Title: Reply LS to N4-040247 (S3-040208) on use of authentication re-attempt IE
Release: Rel-6
Work Item: Security

⌘ **33.102 CR XXX** ⌘ rev **6.0.0** ⌘ Current version: **6.0.0** ⌘

Title:	⌘ Clarification on Authentication re-attempt parameter		
Source:	⌘ SA WG3		
Work item code:	⌘ TEI6	Date:	⌘ 12/05/2004
Category:	⌘ F	Release:	⌘ Rel-6
	Use <u>one</u> of the following categories:		Use <u>one</u> of the following releases:
	F (correction)	2 (GSM Phase 2)	
	A (corresponds to a correction in an earlier release)	R96 (Release 1996)	
	B (addition of feature),	R97 (Release 1997)	
	C (functional modification of feature)	R98 (Release 1998)	
	D (editorial modification)	R99 (Release 1999)	
	Detailed explanations of the above categories can be found in 3GPP TR 21.900 .		Rel-4 (Release 4)
			Rel-5 (Release 5)
			Rel-6 (Release 6)

Figure 13: Reporting authentication failure from VLR/SGSN to HLR

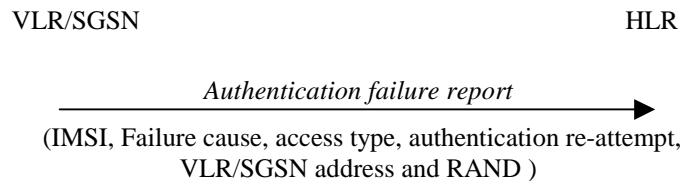
Reason for change:	⌘ The authentication re-attempt parameter was introduced in REL4 to be used by a Fraud Detection System (FDS) in the Home Network to help identify and manage potential fraud scenarios. However, it was pointed out by the CN4 LS (S3-030672) that the detailed usage of this parameter is unclear. Besides, CN4 requested SA3 in the later LS (N4-040247) to provide more information in the 33.102 about the criteria when the authentication re-attempt parameter is set in VLR and SGSN. Therefore, this CR proposes to provide all criteria the authentication re-attempt parameter is set in VLR and SGSN.
Summary of change:	⌘ This CR proposes to add new sub clause to describe the all criteria the authentication re-attempt parameter is set in VLR and SGSN.
Consequences if not approved:	⌘ Due to unclear definition of the authentication re-attempt parameter, VLR and SGSN may not be designed properly and this may lead the FDS function ineffective.

1. Subscriber identity;
2. Failure cause code. The possible failure causes are either that the network signature was wrong or that the user response was wrong;
3. Access type. This indicates the type of access that initiated the authentication procedure;
4. Authentication re-attempt. This indicates whether the failure was produced in a normal authentication attempt or it was due to an authentication re-attempt (there was a previous unsuccessful authentication). [Details are provided in subclause 6.3.6.1](#);
5. VLR/SGSN address;
6. RAND. This number uniquely identifies the specific AV that failed authentication.

[6.3.6.1 Authentication re-attempt](#)

[The serving network sets the Authentication re-attempt to “true” if the second authentication described in the following cases results in an authentication failure report.](#)

- [Authentication with \(P-\)TMSI failed in MS \(reject cause 'MAC failure'\) and new authentication procedure \(re-attempt\) is taken because an IMSI obtained by the followed IDENTITY REQUEST procedure does not match to the original IMSI that linked with \(P-\)TMSI.](#)

- [Authentication failed in MS \(reject cause 'GSM authentication unacceptable'\) and new authentication procedure \(re-attempt\) is taken after MSC obtains UMTS authentication vectors from HLR.](#)

- [Authentication failed in MS \(reject cause 'synch failure'\) and new authentication procedure \(re-attempt\) is taken after MSC obtains new authentication vectors from HLR for re-synchronisation.](#)

- [SRES mismatches with \(P-\)TMSI in VLR/SGSN and new authentication procedure \(re-attempt\) is taken because an IMSI obtained by the followed IDENTITY REQUEST procedure does not match to the original IMSI that linked with \(P-\)TMSI.](#)

[Otherwise Authentication re-attempt is set to "False"](#)
